Appendix I of RNTPC Paper No. A/TM-SKW/127B

Proposed Temporary Place of Recreation, Sports or Culture (Hobby Farm) for a Period of 3 Years & Excavation of Land at Lot 1393 RP in D.D.375, So Kwun Wat, Tuen Mun, N.T.

TPB Ref.: A/TM-SKW/127

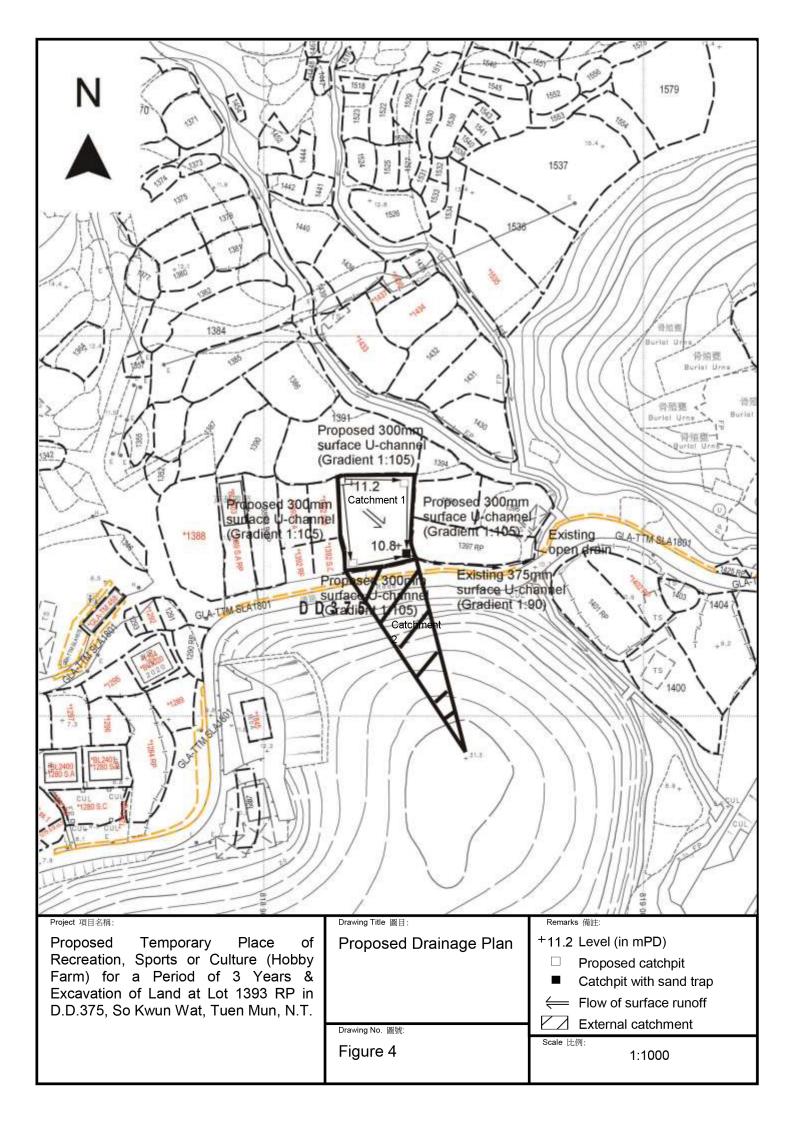
Applicant states no filling of land but the plan shows that only 300sq.mt to be used for farming. So 40% of the site will effectively be built over. That equates filling of land.

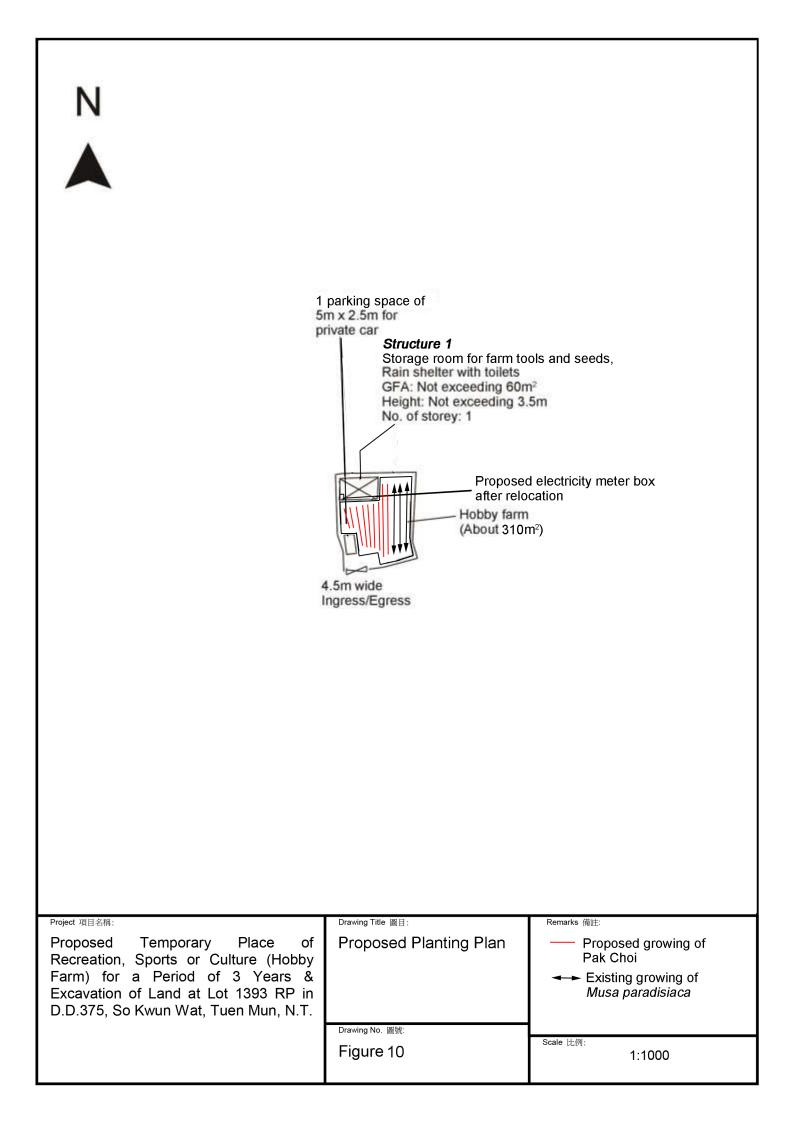
DLO/TM's comments	Applicant's response
a. It is noted from the FI that the applicant will	The applicant will relocate the electricity meter
relocate the unauthorized meter box within the	box to the temporary structure 1 as shown in the
site not covered by the planning application to	updated layout plan (Figure 3) in the
the proposed structure.	attachment.

It is noted from the F.I. that the applicant will relocate the unauthorized meter box to the temporary structure 1 as shown in the updated layout plan (Figure 3). In this connection, the applicant is requested to clarify whether the meter box upon relocation serving the proposed temporary place of recreation, sports or culture (hobby farm) only.

We have updated Figure 3 and Figure 10 to show the proposed area for hobby farm. It is noted that the updated cultivation area is kept at $310m^2$ which is about 62% of the application site will be reserved for cultivation.
